St Michael's Place Masterplan, Huyton Town Centre

Transport Assessment Addendum

A25008

Figure 1 - DfT Connectivity Tool Assessment

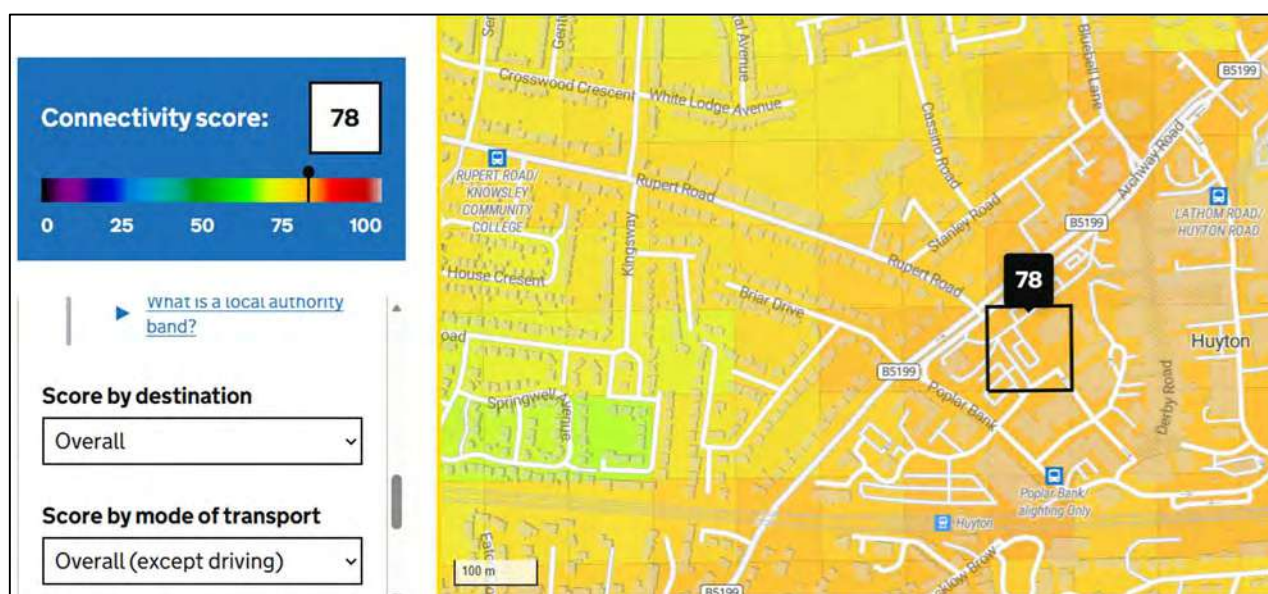
- 3.10. In terms of considering whether the existing public transport network has the capacity to absorb the displaced trips in more detail, Astute have reviewed the Department of Transport's (DfT) Connectivity Tool, which provides information on a site's level of accessibility by all modes of transport for all journey purposes. This assessment compares the site's connectivity with all other areas within Knowsley and the Liverpool City. The output of this assessment (overall except driving) is provided in **Figure 1**.

- 3.11. The above assessment scores the site around 78 and it is within Band A, which is the highest band for connectivity across KMBC. It can be concluded therefore that the site location is well suited for supporting travel to / from Huyton Town Centre using public transport and active travel modes.

Figure 2 - Coach Drop-Off Arrangement on Civic Way

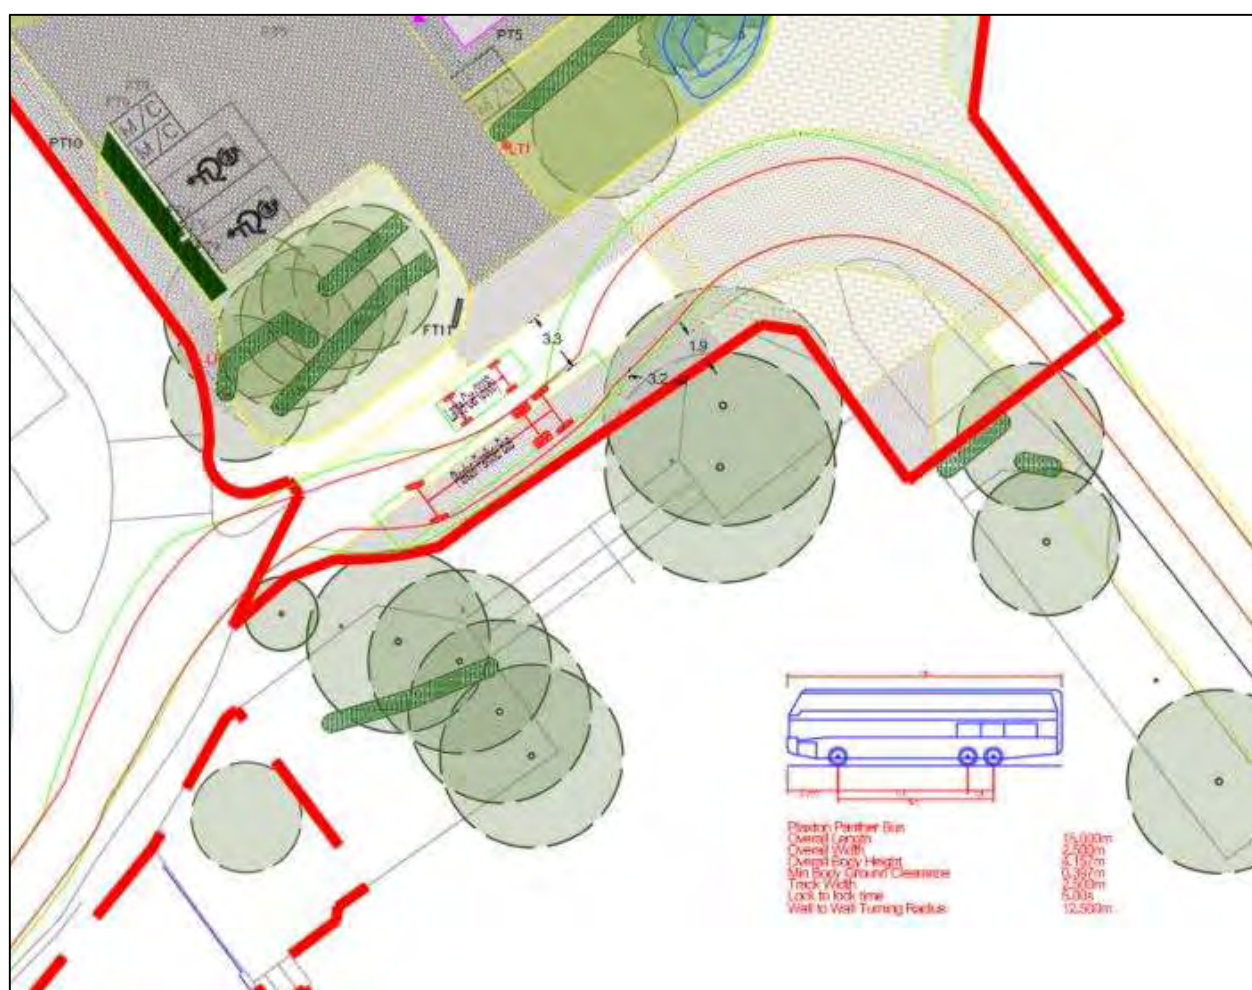
Servicing - Coach Drop-Off on Civic Way - The comments from the LHA are provided in the Highways Consultation Response issued on the 27th April 2026.

Civic Way to create the coach bay area with some alterations to the geometry. Hotel guests will board and alight from coaches using the adjacent footway and cross Civic Way to the rear of the parked vehicle, where the proposed raised table and active travel infrastructure on either side is the same level. This provides access to both the Village Green and the main hotel entrance. The public realm streetscape design will provide a safe arrangement for pedestrians with appropriate visibility splays / sightlines to assimilate oncoming vehicles, and the raised table will ensure low traffic speeds on this part of the highway network that will be lightly trafficked in the future following the completion of the St Michael's Place development proposals. The pedestrian crossing location will comprise of tactile paving on either side of the raised table road surface to assist mobility impaired users. The coach drop-off arrangement on Civic Way and the pedestrian access to / from the hotel is detailed in **Figures 2 and 3**.

Figure 2: Summary of Recorded Traffic Flows - Lathom Road ATC, June 2025

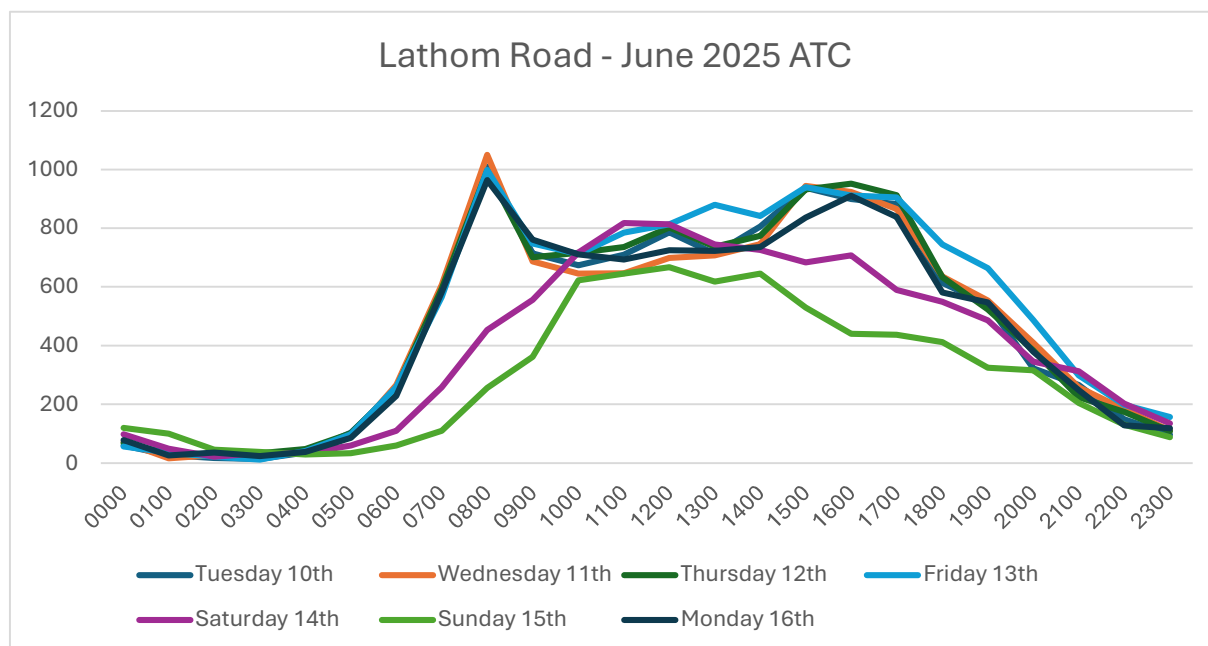
- 4.18. At the request of KC, **Figure 2** has been prepared to show traffic flows recorded by an Automatic Traffic Counter (ATC) in place on Lathom Road between Tuesday 10th June and Monday 16th June 2025.

- 4.19. **Figure 2** confirms that the adoption of weekday AM (08:00-09:00) and PM (16:30-17:30) peak periods for the assessment is appropriate.
